# QUESTIONS FROM EP SAFETY GROUP FROM JAMES DEVINE OCT. 15<sup>th</sup> 2020

## MoEDAL-MAPP responses by James Pinfeld

Figure 1 LEP drawing of the TX84/UGC1 region showing the wall between the LHC tunnel and the UGC1 gallery

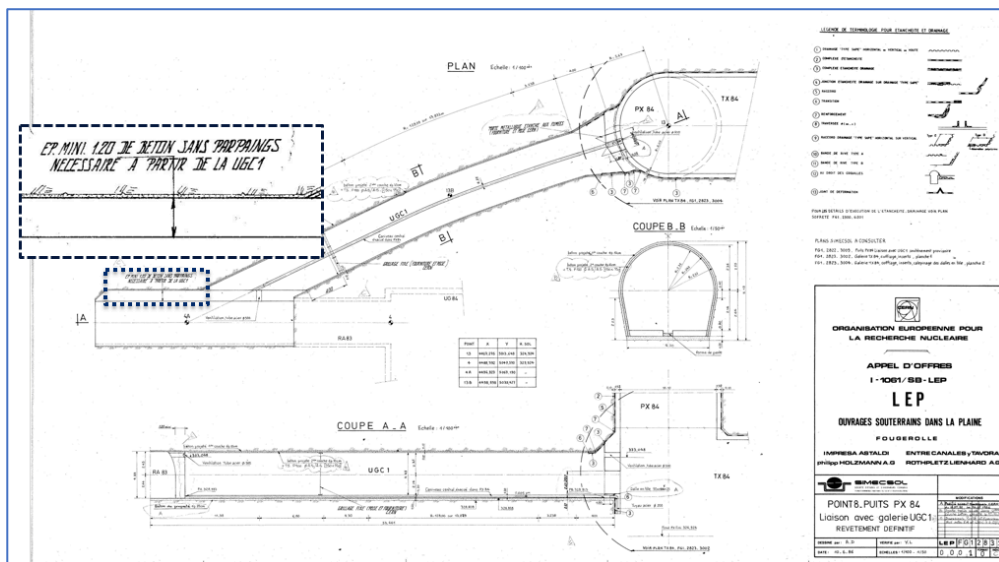
Question: *Do you have a design/specification in mind for this wall, in terms of thickness, construction material/method? My default assumption would be a standard modular concrete block construction, but equally I know there are some more exotic solutions such as lead bricks and water filled barriers in a couple of locations at CERN. Also, in terms of the radiation calculations, is this something that you would do yourself or would you require support from the FLUKA teams at CERN?*

*The main reason for this question is that if standard shielding concrete blocks are to be installed at the end of the gallery, then the CERN transport service will have requirements for the finished floor (flatness + loading) in order to handle and install them. These are likely to be the heaviest items to be transported into UGC1, and will thus set the parameters for a safe access and transport system to/from the LHCb shaft.*

We have recently learned from the drawing LEP 1 drawing of TX84 and UGC1 and the adjacent LHC tunnel shown in Figure 1, that the UGC1 gallery is separated by a concrete wall 1.2m thick. This is substantially thicker than our supposition that this was simply a curtain wall of thickness 30 cm to 40cm.

Based on this Francesco Cerutti and Alessia Ciccotelli of the Beam-Machine Interaction section of the CERN Engineering Department prepared a preliminary report on estimates of beam induced backgrounds in the UGC1 gallery in the vicinity of the LHC tunnel, using the FLUKA Monte Carlo program. This report clearly indicates that we now longer need to enhance the thickness of the wall separating the UGC1 gallery from the LHC tunnel. Consequently, there is now no need to transport shielding blocks into the UGC1 gallery obviating the need for a finished floor.

Figure 2 A drawing of the mu-metal shield for the MAP Phase-2 detector

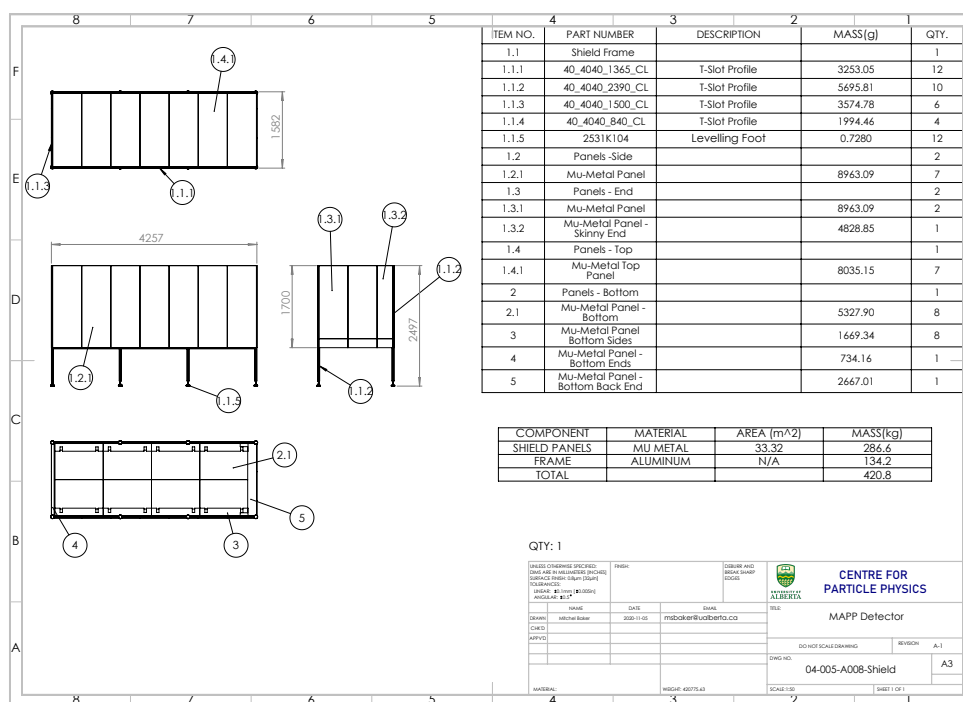
As mentioned by Manfred, we've already had a preliminary discussion on the subject of plastics with HSE. They confirmed that the existing derogation is valid as is, but that a new one would be required for the 3 tonnes of PS scintillator. I see from Page 17 of the TDR that this will be encased in a mu-metal flame shield, also weighing 3 tonnes. Is this the correct weight for the flame shield? If so do you have a plan in mind for installing it (for example a lifting rail in the cavern to suspend it during installation, or smaller sections bolted together)?

We are not sure where your quoted mass of 3 tonnes for the mu-metal shield comes from<sup>1</sup>. In any case, the TDR now gives a substantially smaller mass for the mu-metal shield of 287 kg. However, as can be seen from the drawing in Figure 2, the mu-metal shield will be assembled sheet by sheet. The largest sheets weigh only 5.3 kg.
